2003-11-06 IEEE 802.16e-03/66

## Changes on Sleep mode SDL Diagram

#### Changhoi Koo, Hyunjeong Kang and Jungje Son

Figure 106d—SS Listening SDL Diagram Figure 106d—SS Listening SDL Diagram

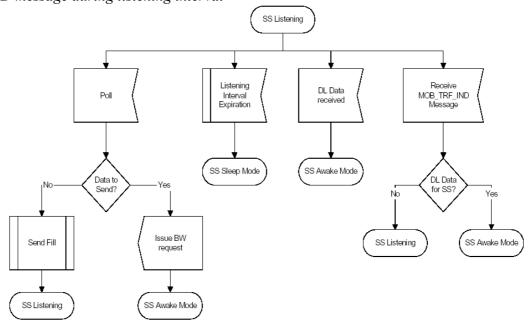
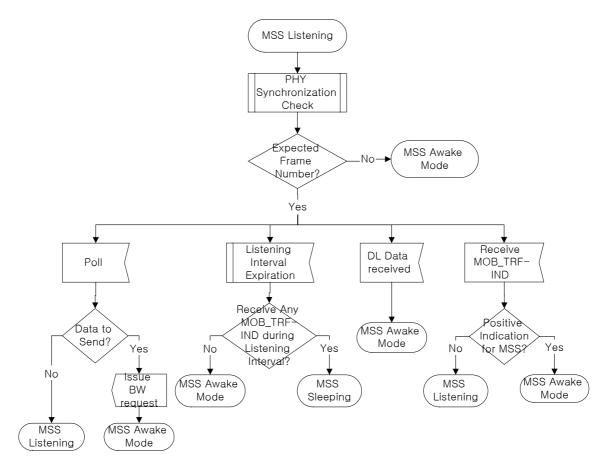
### **Proposed Changes to Figure 106d**

- Delete 'Send Fill'
  - ♦ There is no any mentioning in IEEE 802.16e-03/07r4 about sending Fill bytes when MSS is polled but has no data to send.
- Insert the process for 'checking the frame number of PHY Synchronization Field to verify the synchronization with the BS'
  - ◆ To make the MSS operation, during listening interval, firm and consistent with contents in 6.4.16.3(P.35, 3~7)
- Change 'DL Data for SS?' to 'Positive Indication for MSS?'
  - ◆ To make consistency with MOB TRF-IND message and contents through IEEE 802.16e-03/07r4
- Insert the process for 'checking whether MSS doesn't receive any MOB\_TRF-IND message during listening interval'
  - ◆ To reflect commentary #70 for considering an abnormal case that MSS didn't receive any MOB\_TRF-IND message during listening interval

[Replace Figure 106d with the following:]

Figure 106d – MSS Listening SDL Diagram
